Date	Ref. No.	Model	
22.01.09	09HV002	RDR-GX120, RDR-GX220, RDR-GX330, RDR-GXD360, RDR-HX520, RDR-HX525, RDR-HX720, RDR-HX722, RDR-HX725, RDR-HX727, RDR-HX730, RDR-HX920, RDR-HX925, RDR-HXD560, RDR-HXD760	HV
Subject			IRIS
Set Freezes after "WELCOME" Message on FL Display			1110

IC601 measurement position

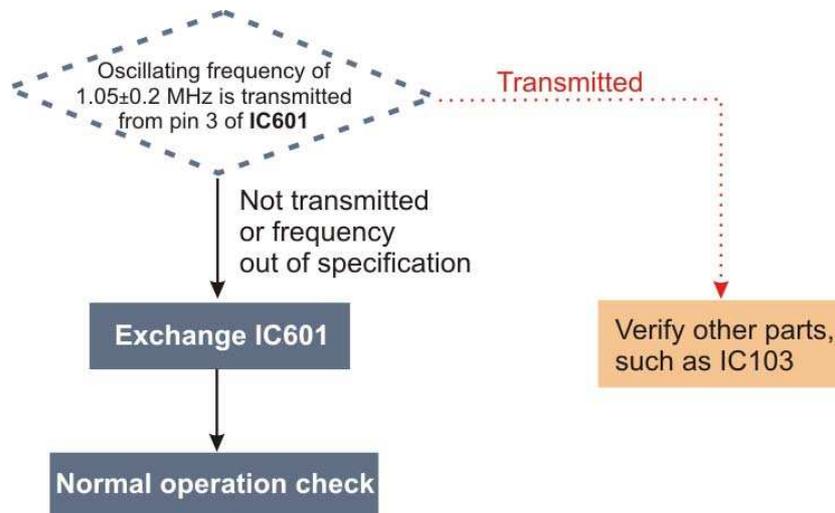
Voltage output of the DC-DC converter IC is not correctly stabilized.

- The output of the DC-DC converter is a square pulse. Please measure at pin 3 of the IC, using an oscilloscope. Check that the signal is within the [WAVEFORM] specifications. Proceed according to the flowchart below.

- Refer to the table below when exchanging IC601.

Board	Ref.	Description	Part number
RD-060	IC601	IC MP2105DJ-LF-Z	6-708-889-01

- After exchanging IC601, confirm the oscillation frequency to the below values.

Oscillating frequency	$1.05 \pm 0.2 \text{ MHz}$: 0.85~1.25 MHz
Interpulse time	$952 \pm \begin{matrix} 224 \\ 152 \end{matrix} \text{ ns}$
